## INFORMATION FORM – SEPTIC SYSTEM REPAIR/UPGRADE

Property Address: 2445 THOMPSON DRIVE County file: 286606

# SITE INSPECTION SHEET

**Picture 2:**

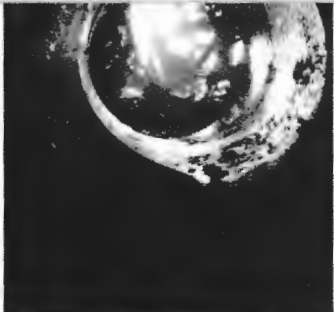
This shows the riser on the tank is collapsing.

## LOCATION DIAGRAM

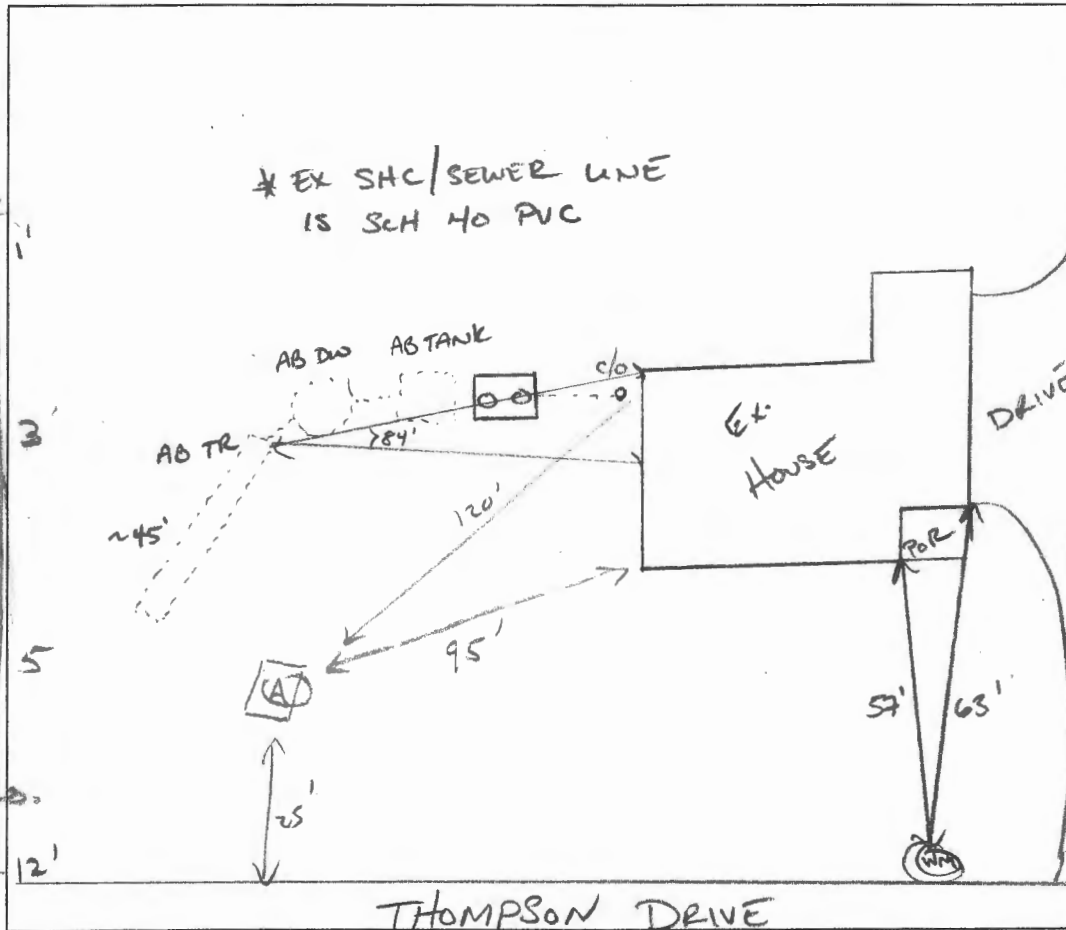
COMMENTS: PUMPED AND COLLAPSED CINDERBLOCK TANK AND  
DRY WELL. A TRENCH WAS DISCOVERED, COMPLETELY FULL OF  
BIOMAT/SOLIDS AND SLUDGE ~1' ABOVE TERRA COTTA PERF PIPE  
INVERT W/STANDING WATER IN AGGREGATE.
